SEWAGE DISPOSAL TESTING

MARYLAND STATE DEPARTMENT OF HEALTH

PROPERTY OWNER Robert H. and Vestie Souder

PLAT OF SURVEY
 FOR
 ROBERT H SOUDER
 SIXTH ELECTION DISTRICT OF HOWARD COUNTY
 LAUREL, MARYLAND
 SCALE: 1 IN. = 50 FT. APRIL 19, 1968

INDICATE NORTH. - NAME ADJOINING ROADWAY AS BASE LINE.

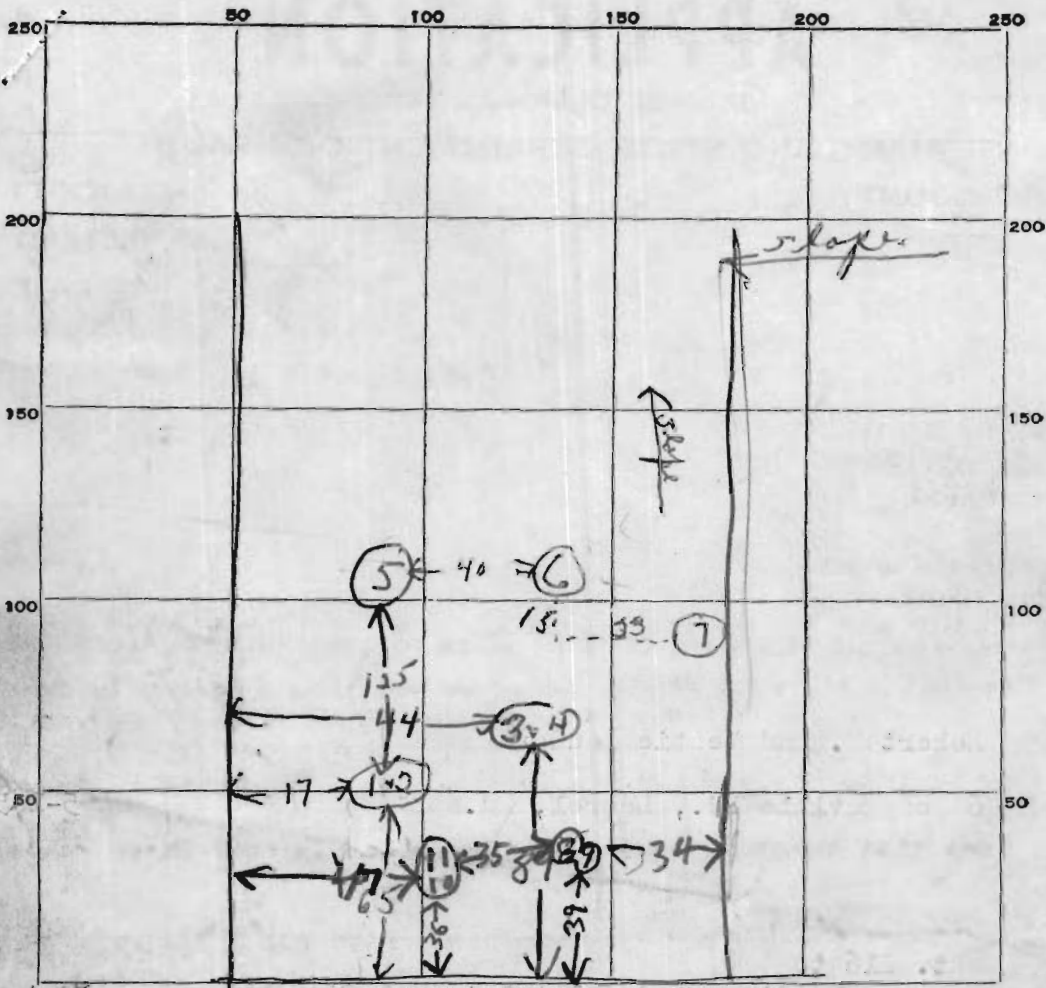
Dry well 480 sqft sidewall area below the inlet with a maximum depth of 14 ft

Dry Well 640 sqft sidewall area below the inlet with a maximum depth of 14 ft

Use a 12 FT top and a square hole 15 FT long on each side

Use a 12 FT top and a square hole 15 FT long on each side

Place the dry well 35 ft from the front lot line and 35 FT to 70 ft from the right side of the lot as seen when facing the lot from Harding Road

REASONS FOR REJECTION OR HOLDING 10/29/64 - no gas - high water - on poor soil - dur. 5/1/68 - Hold for plat & A.C. plans showing

Location, Elevation of septic system & system must be finished & approved before building permit issued

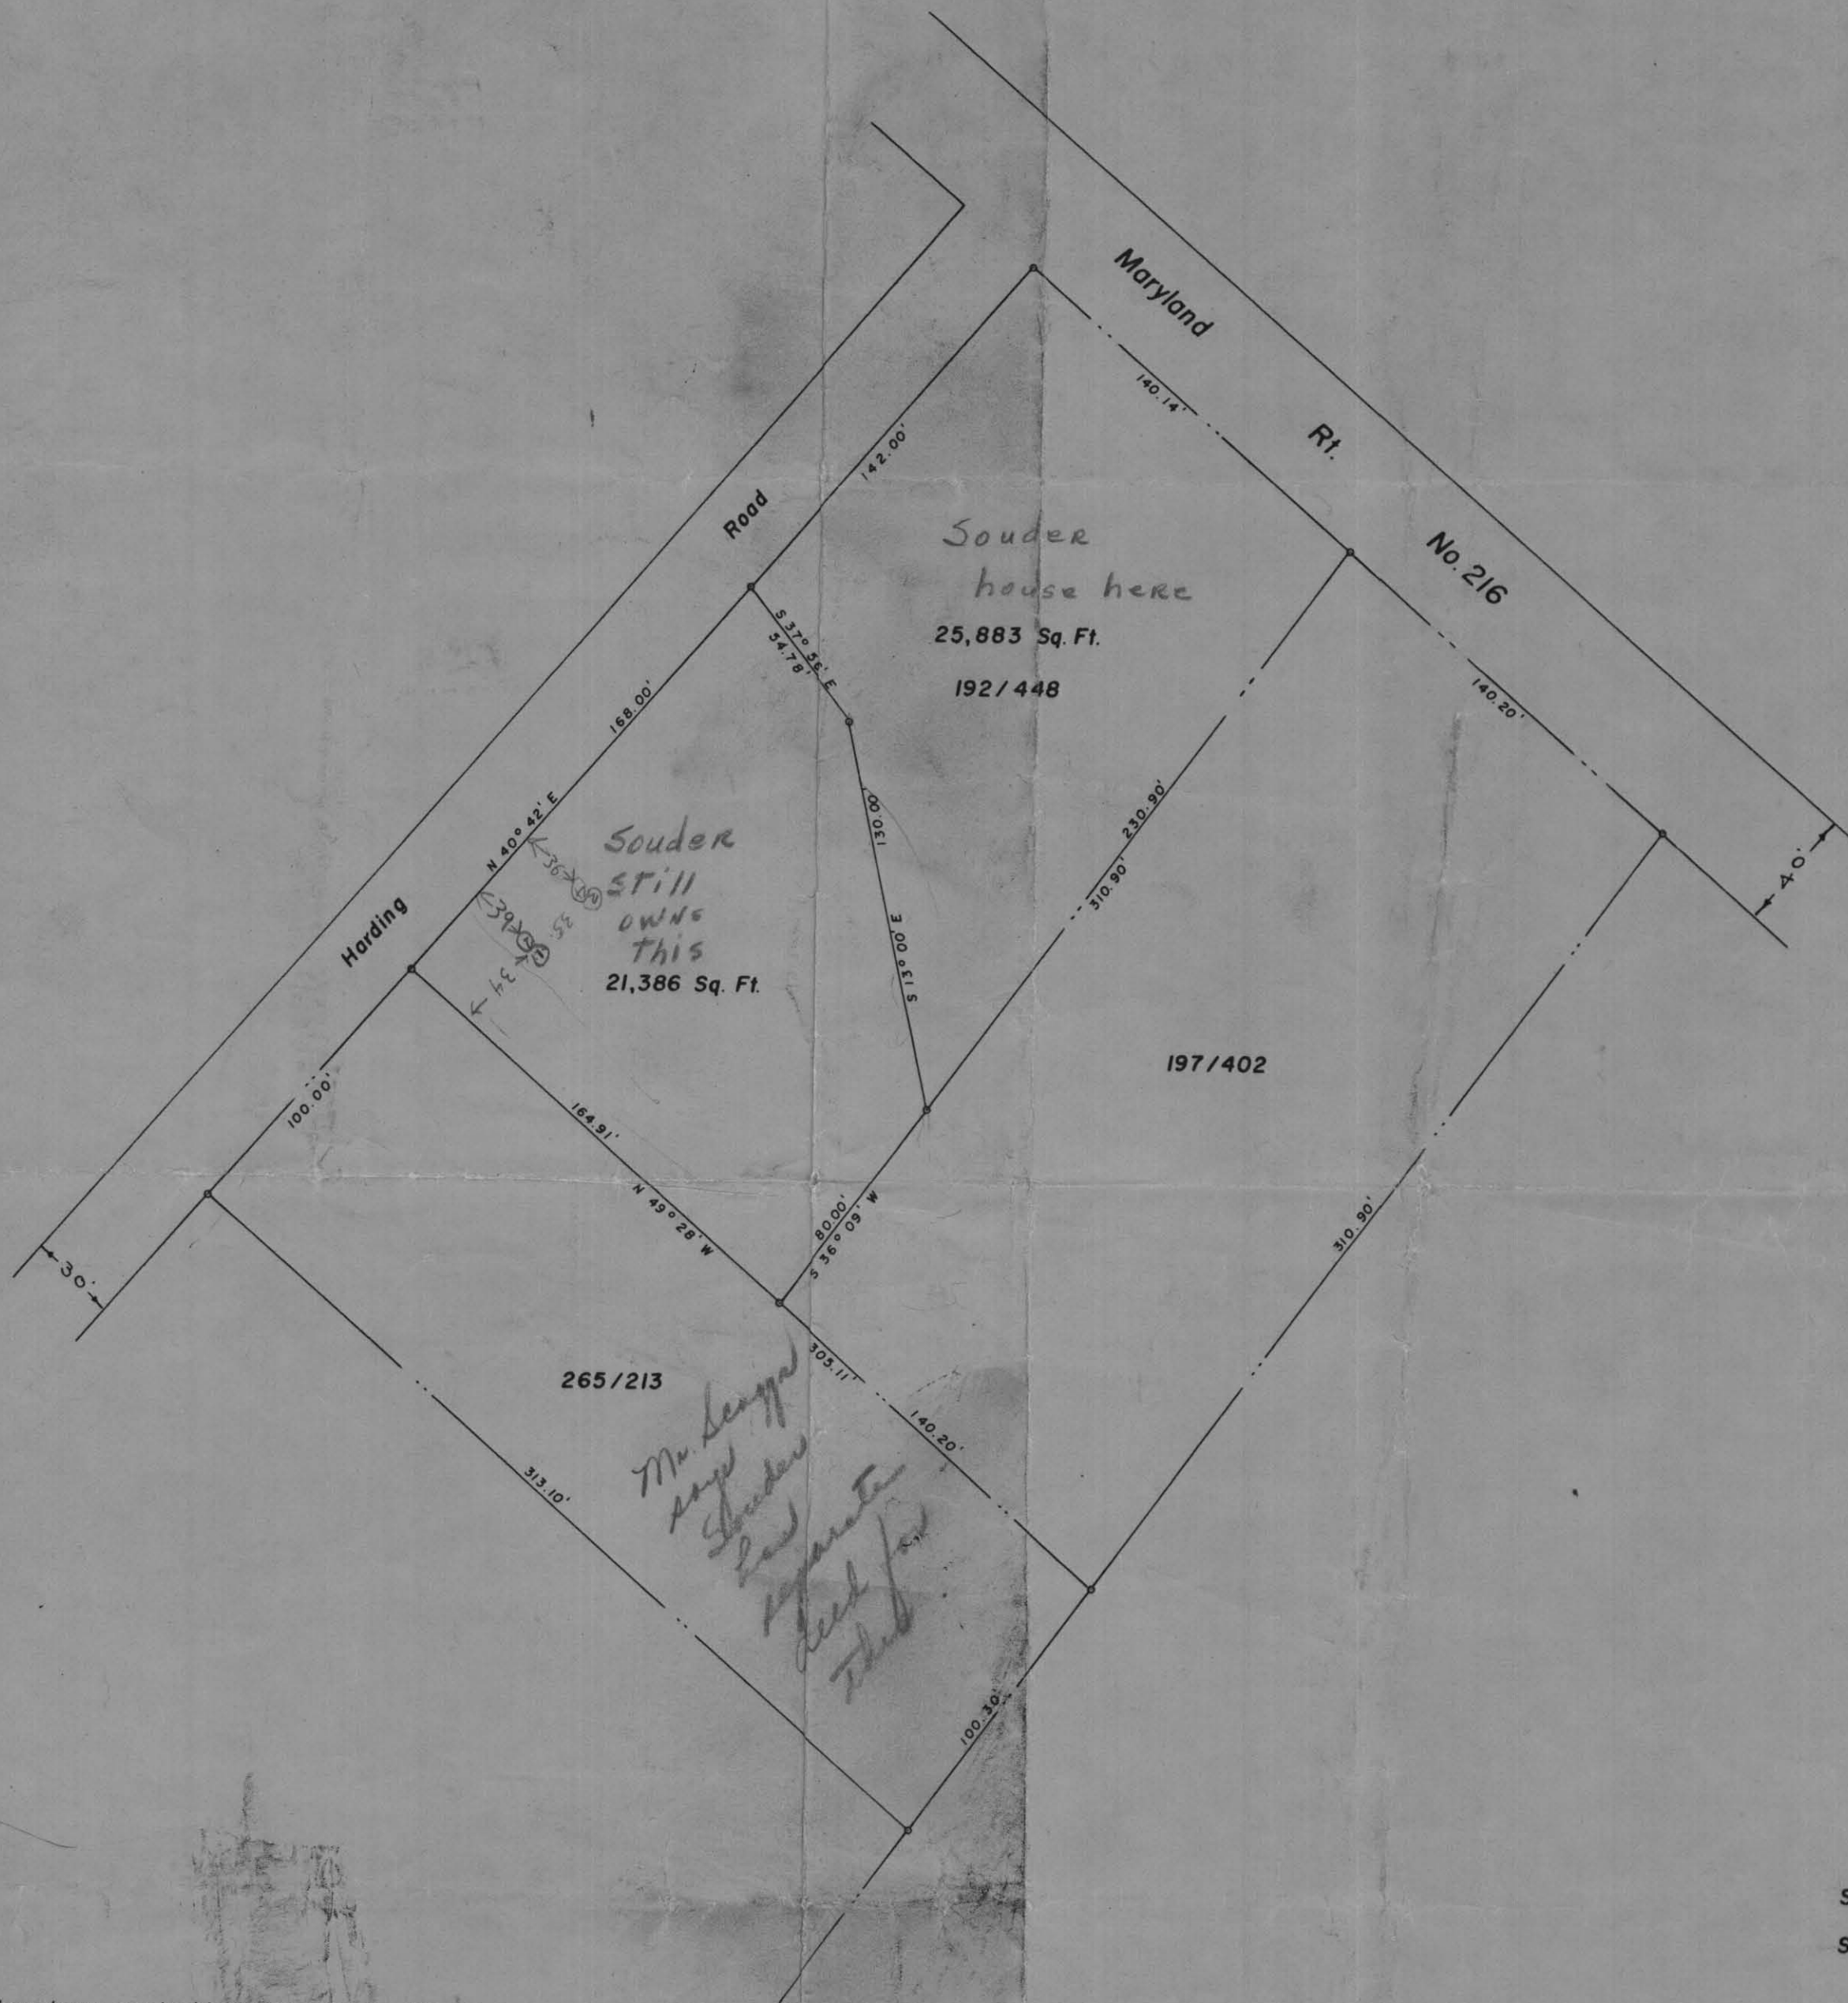
On the plat of your property located on Harding Road and Route 216, make a note that the lots must have city water. There is a place for Dr. Shrop to sign the plat but there is no indication as to whether or not the lot will have city water. The percolation test was rather slow on the 21,386 ft. lot on Harding Road. Therefore, this lot can be approved for building only on the condition that city water is available.

1. Submit plans to this office showing the location and elevation of the sewage disposal system and house.
2. Have the plans approved by this office.
3. Build an approved septic system according to the approved plans.
